Transition time in MMF transmitters

Transmitter transition time in Clauses 193 and 194 — comments #34 and #74 against D1.2

IEEE P802.3ds D1.2, 200 Gb/s per Wavelength MMF PHYs Task Force

Comments 34 and 74

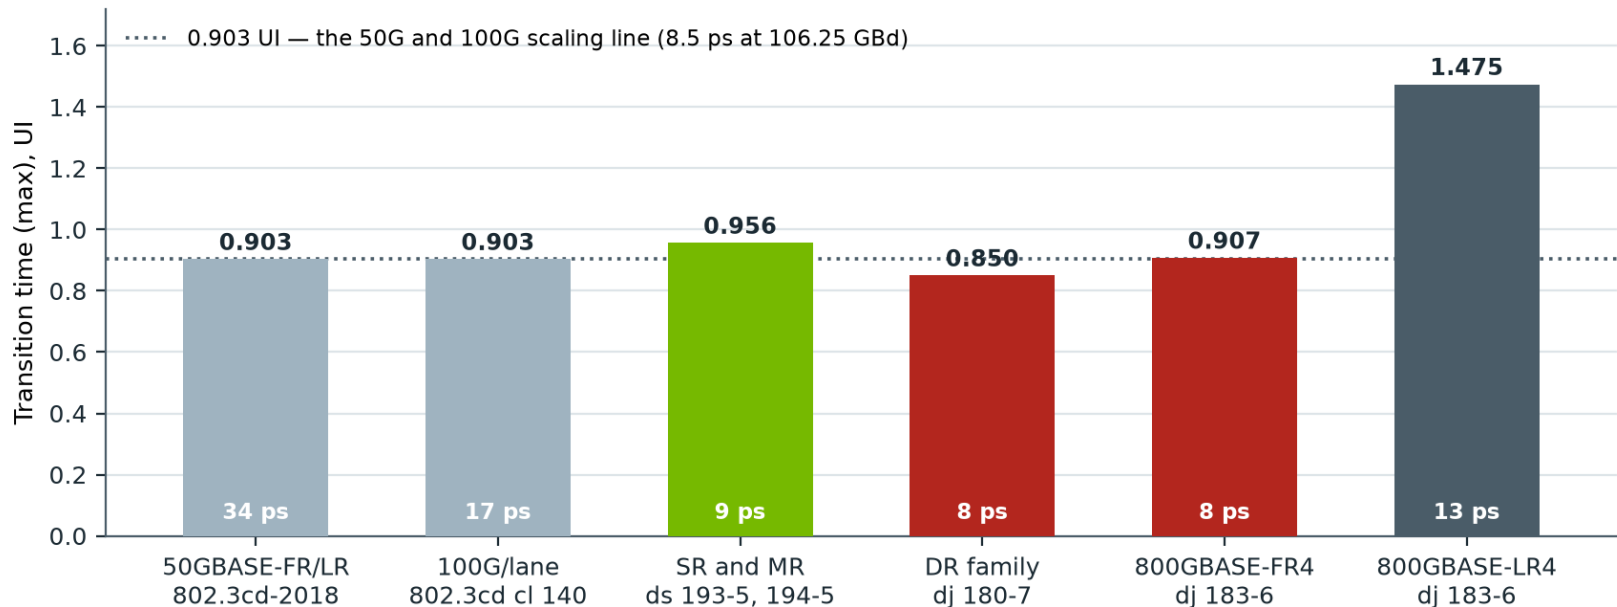
CI 193, SC 193.7.1, P57 L39 — Pending CRG discussion

#	Commenter	Type	Remedy asked for	Proposed response
34	Simms, NVIDIA	T	9 ps → 10 ps	pending CRG review with 74
74	Dawe, NVIDIA	TR	Delete the row; or 13 ps, as for 800GBASE-LR4	pending CRG review

- **The two comments approach the problem differently.** Deletion is the cleanest outcome, 13 ps is comfortably safe, and 10 ps is the least disruptive change that still fixes the defect. This contribution supplies the measurement that decides between them [2,3].

Backup: the same reading, different signals

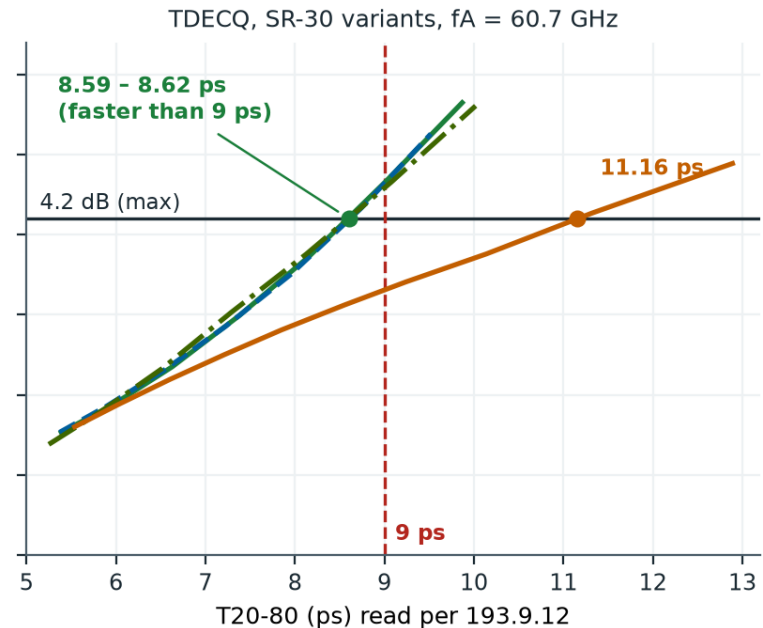
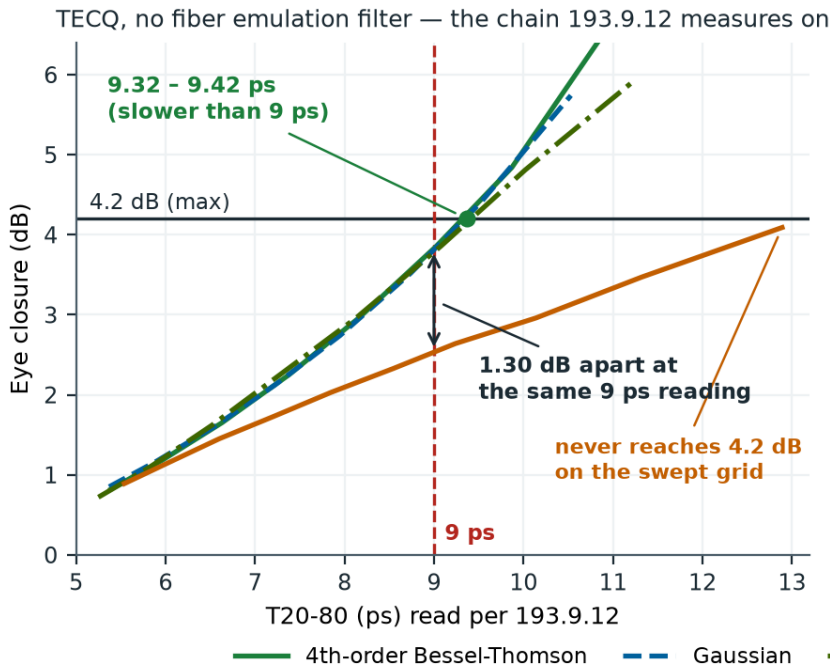
Eye closure against the transition time a conformance test would read, by transmitter shape

- **The three simple rolloffs are one curve.** Bessel-Thomson, Gaussian and 2nd-order Butterworth are indistinguishable here, which is why the tables quote them as a narrow range rather than three cases. The single pole is a different line: at the same 9 ps reading it sits 1.30 dB lower in TECQ [9].

- **The crossings fall on opposite sides of 9 ps.** Without the fiber emulation filter the adopted 4.2 dB is not reached until 9.32 – 9.42 ps, so transition time binds first; with it the same limit is reached at 8.59 – 8.62 ps, so TDECQ binds first. SR-30 is drawn because its fA is the widest of the three, and so the weakest case for that second point; MR and SR-50 move the crossing to 8.01 ps.

- **The single pole is the exception, and it is disclosed.** With the filter in the path it does not reach 4.2 dB until 11.16 ps, so for that shape the 9 ps limit is what binds. The table on the previous slide gives the transmitter bandwidth such a part needs, and it is 20 GHz.
